CITY OF ALBUQUERQUE

RE: De Anza Grading Plan and Drainage Master Plan Stamp Date: 12/13/17 Hydrology File: K17D106

PO Box 1293 Based upon the information provided in your submittal received 01/02/2018, the Grading Plan and Drainage Master Plan **are not** approved for Building Permit. The following comments need to be addressed for approval of the above referenced project:

DRAINAGE

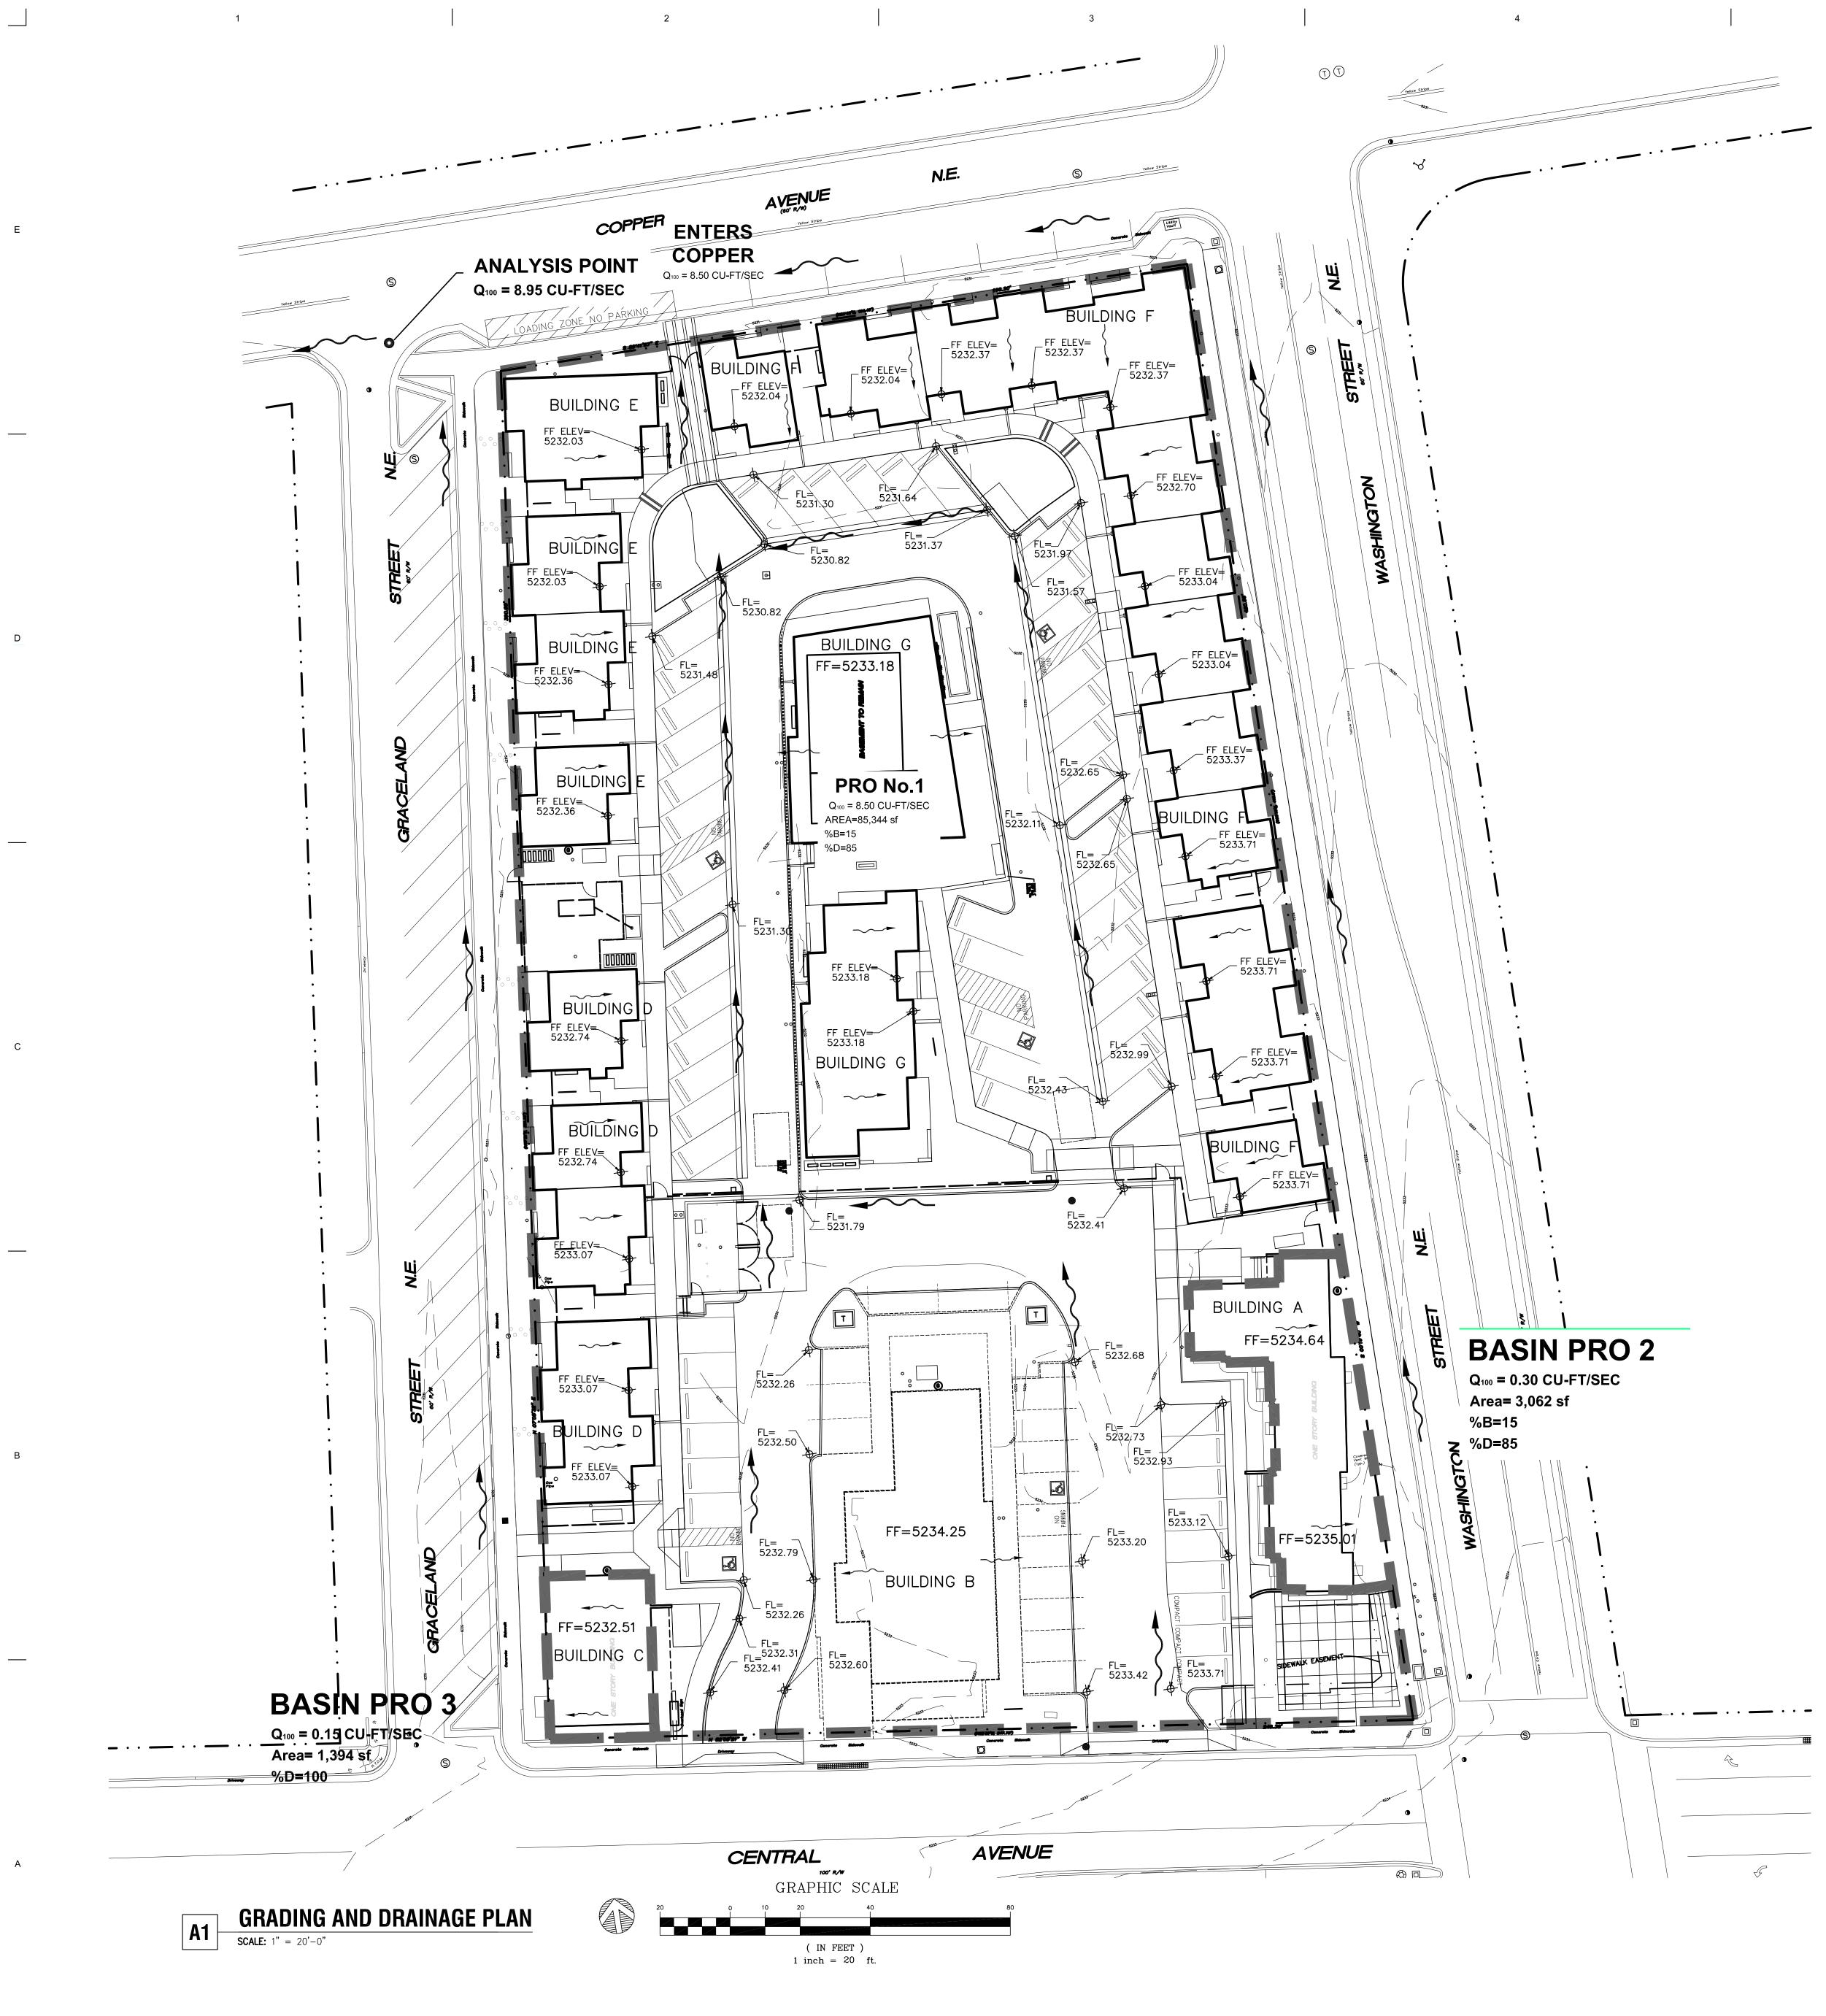
- 1. Sheet CD1 & CD2. Please provide an engineer's stamp with a signature and date on sheets.
- NM 871032.The first flush required is 1,571.8 cubic feet. If you want to do the Fee in Lieu,
then the payment (Amount = 1,571.8 CF x \$8/CF = \$12,574.40) for the required
first flush volume must be made. Please add a note on CD1 that states a payment
for the Fee in Lieu for the required first flush volume will be made instead of
building the first flush ponds.

Please just resubmit Sheets CD1 & CD2.
